| Model: Top Drive Serial #: 1161-1349 | Feb. 14, 2017 |
| Product Bulletin #: TDS-165 | |

Top Drive Plenum Heater

Figure 1: Relay 2 is located on Rail 4 in the CIP

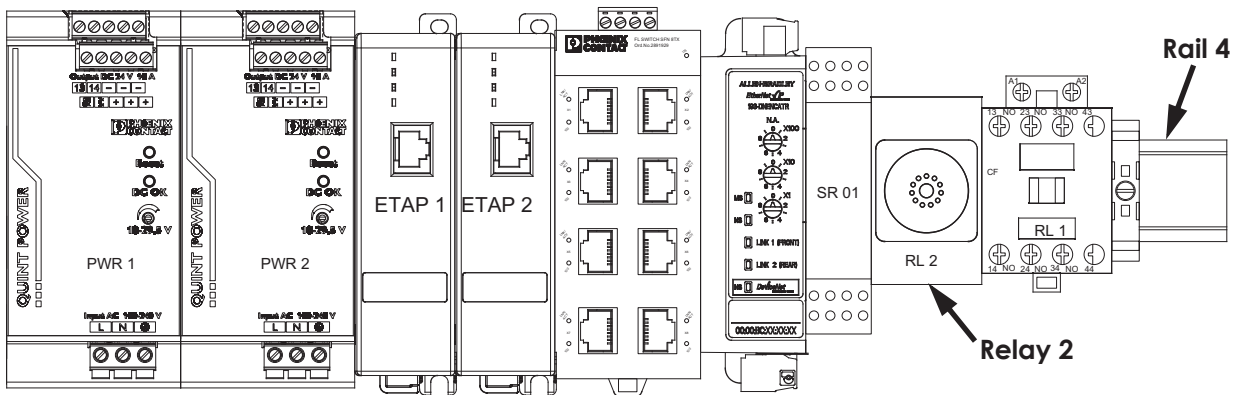
1. Remove all power to the Top Drive CIP (Control Interface Panel). Perform Lock-out/Tag-out (LO/TO) procedure before proceeding.
2. Using multimeter, ensure there is no voltage present to the cabinet and Relay 2 located on Rail 4 (See Figure 1 on page 2).
3. Inspect Relay 2 to ensure wiring is correct. For correct wiring see Figure 2 on page 3:
 - a. If wiring is correct, perform Step 8 on page 2 and reverse Step 1.
 - b. If wiring is not correct, proceed to Step 4.
4. Remove wire number 160 from terminal 3 and terminate to terminal 1. Remove wire number 376 from terminal 1 and terminate to terminal 3 (see Figure 2 on page 3).
5. Remove wire number 157 from terminal 7 and terminate to terminal 6.
6. Remove wire number 178 from terminal 9 and terminate to terminal 11.
7. Reverse top drive lock out and Lock-out/Tag-out (LO/TO) procedure and test wiring.

Figure 2: Detail of Relay 2 Connections

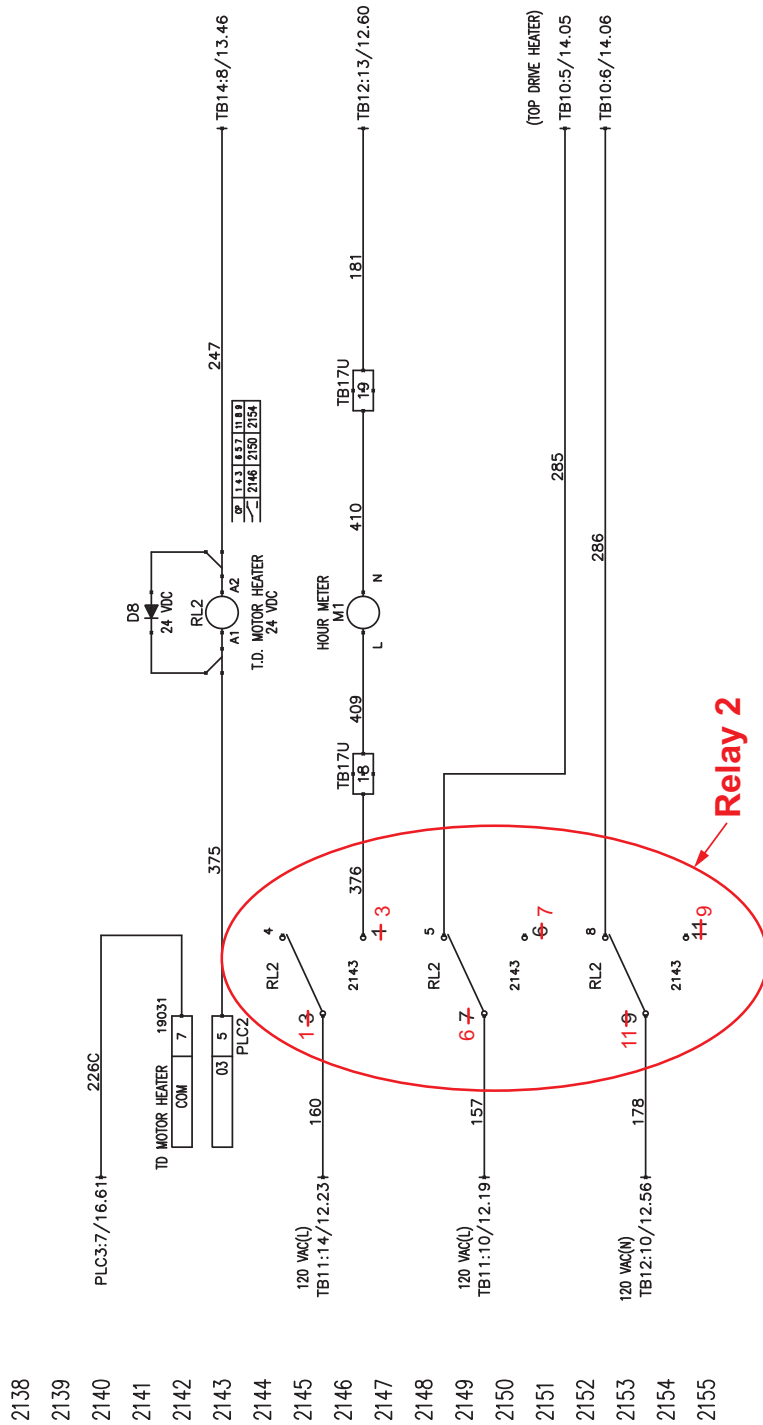
The top drive heater (condensation) has been found to not operate correctly on several delivered units in the field. Further investigation has found that the heater relay circuit has been wired incorrectly due to inaccurate schematics on some top drives.

8. Test each circuit using the multimeter:
 - When top drive switch is in the enable position, terminal 3 on Relay 2 should read approximately 120 VAC to TB12 terminal 10. The hour meter should be running.
 - When top drive switch is in the disable position, terminals 5 to 8 should read approximately 120 VAC and the top drive motor heater should be on.
 - When top drive switch is in the enable position, the motor heater should be off and the heater should read approximately 65-ohms between terminals 5 to 8.
9. Update schematics in local manual by redlines (see Figure 2 on page 3).
10. Report completion of this bulletin to RIGLINE 24/7™ Support.
